HISTORIC LANDMARK COMMISSION
MAY 18, 2015
APPLICATION FOR A CERTIFICATE OF APPROPRIATENESS
C14H-1978-0010
Nalle Building
409-13 E. 6th Street

Construct a two-level rooftop deck.

Depiction of an allowable rooftop use from the Architectural Design Guidelines for 6th Street.

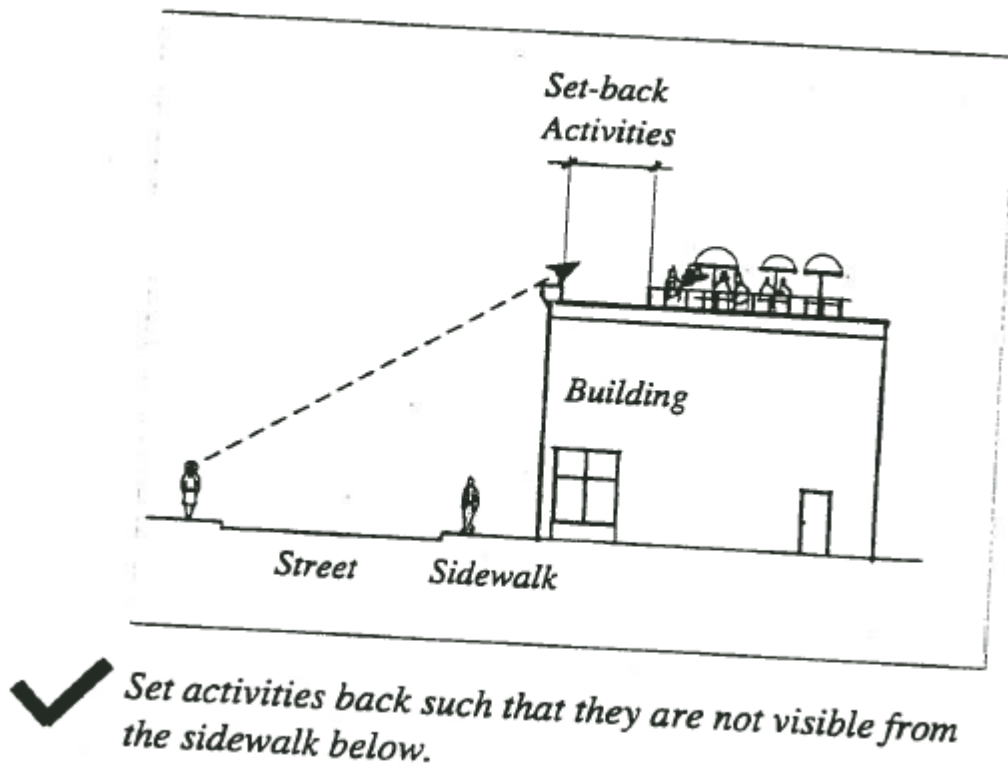
Staff cannot recommend this proposal, and suggests that the upper deck be set back to the point where it is not within the sight line of the street, in accordance with the Architectural Design Guidelines for Sixth Street.
